***Tekran Comments regarding:
Final Technical Report, ICCI Project Number: 10/6A-1***

**“DETERMINING THE VARIABILITY OF CONTINUOUS MERCURY MONITORS (CMMS)
AT LOW MERCURY CONCENTRATIONS”**

Rev 1.03 June 16, 2011

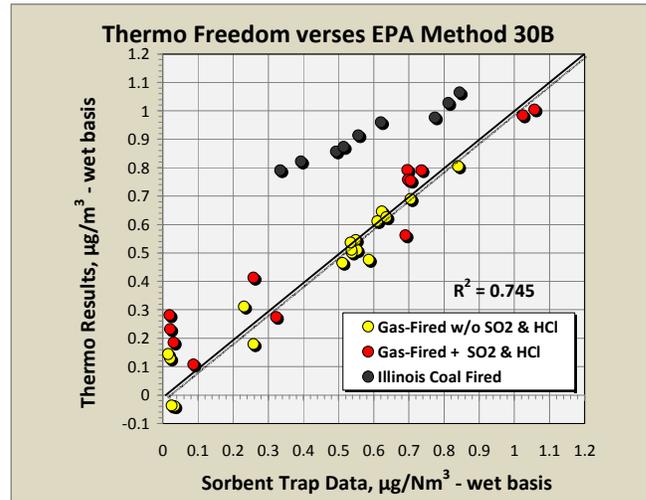
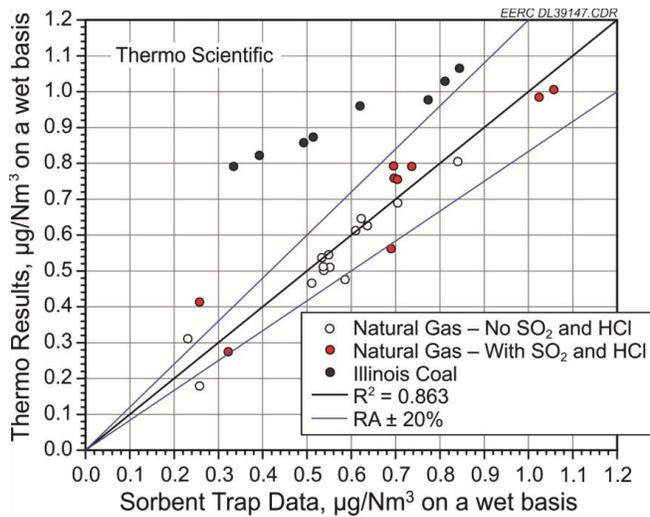
Inappropriate data analysis is used throughout the report, but is particularly evident in Tables 8, 9 and 12. In these tables, each set of CMM results is a varying time series of combustor concentrations. Given that the concentrations vary over time, not only randomly but often with a discernable trend, the standard deviation is not necessarily an indication of instrument “noise”. It is likely that the instrument(s) are measuring legitimate fluctuations in the background concentrations.

By contrast, each trap result is a single integrated value. Replicate trap results, taken over the same time period, would be expected to yield absolutely identical results and the lambda confidence interval would be a valid statistic. (Although an actual result uncertainty would be a more useful indicator.) For example the report states: “Overall, the reproducibility for the quad sorbent trap sampling ($\sigma = 3.6\%$) contributes to a high level of confidence ...” [page 24, para 2].

The standard deviations and the confidence intervals of the CMMs versus the sorbent traps results are totally different measurements and cannot be compared in any meaningful way.

Summary Plot of Results – Tekran [Fig 11]

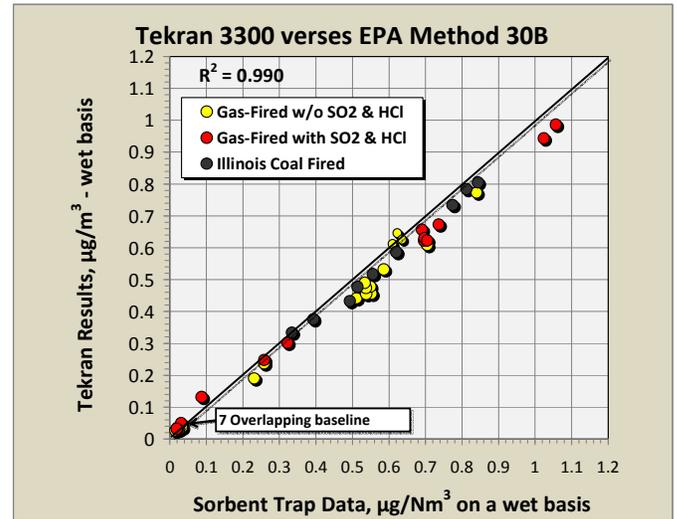
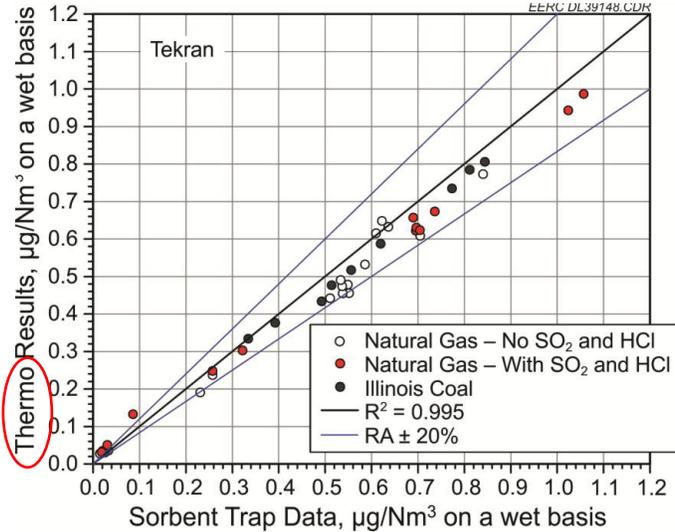
The Y axis label mistakenly says “Thermo”, not “Tekran”. The R^2 value shown on the EERC graph for Tekran incorrect. The 0.995 is actually R , of the full data set, not R^2 . The actual R^2 of the full data set is 0.990.

The graph on the left is from the EERC report. The graph on the right shows the correct R^2 value. Once again, the dark line is the 1:1 line, not the regression line.
